# HISTORIC DISTRICT COMMISSION NOTICE OF DENIAL

**Application Number:** HDC2025-00297

<b>NAME:</b> Nader Afshar & Bardia Madani		<b>COMPANY NAME:</b> N/A	
<b>ADDRESS:</b> 3677 Brookside Dr.	<b>CITY:</b> Bloomfield Hills	<b>STATE:</b> MI	<b>ZIP:</b> 48302
<b>PROJECT ADDRESS:</b> 4758 Sturtevant St. Detroit, MI			
<b>HISTORIC DISTRICT:</b> Russell Woods-Sullivan

the replacement of leaded wood windows with wood windows on the primary facade, and installation of vinyl windows on sides and rear of the house

### Window Schedule

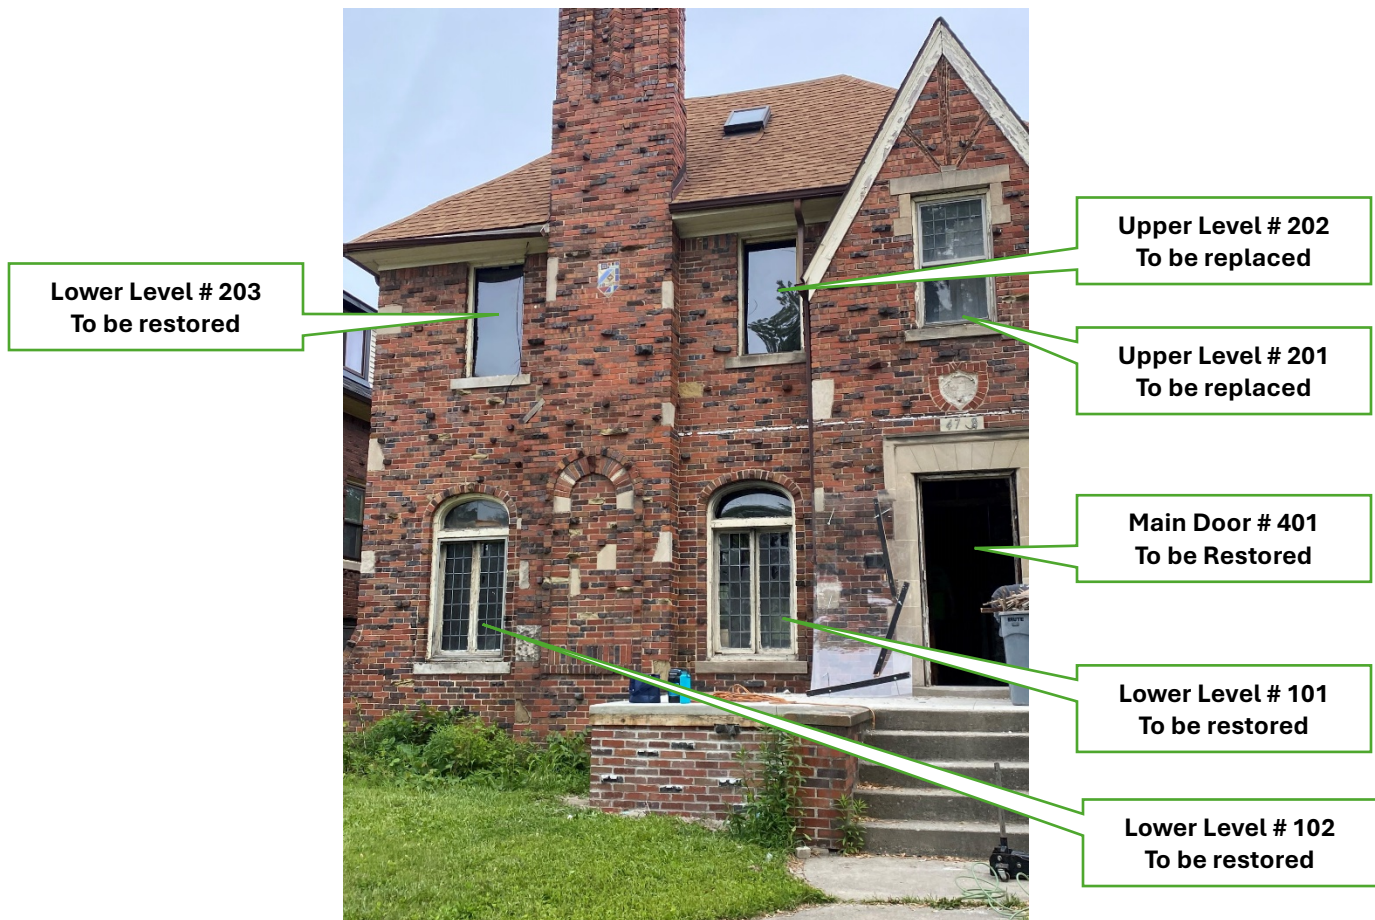
- We need interior photos (labeled) of the following windows: 101, 102, 103, 104, 105, 110, 201, 203

Please note that vinyl is not an approved material. You may want to provide alternative material or use the same material (wood) for the proposed vinyl windows for your project. Additionally, we would like to see physical evidence that the windows cannot be restored rather than replaced. Since there is the proposal of replacing some of the existing historic wood windows, this application will need to be reviewed by the Commission at one of its regularly scheduled public meetings.

- 101, 102, 201, 202 & 203– These windows are to be replaced by wooden windows similar to that which the DHC has approved for other similar homes. Descriptions, color and styles are attached to this schedule for your consideration.

- 102 & 102 – The semicircular top part of these windows will be replaced by glass in the same shape. A template will be created and glass ordered to the same shape.

- All other windows are presently completely blown out due to fire or water pressure. These windows will be replaced with:
  - Single Hung vinyl windows

- 2 to 4 panels in each window
  - Screen on the lower part (opening part)
  - Some windows are picture windows which do not open. These windows will be replaced by similar picture windows. See #103, 104 & 105.
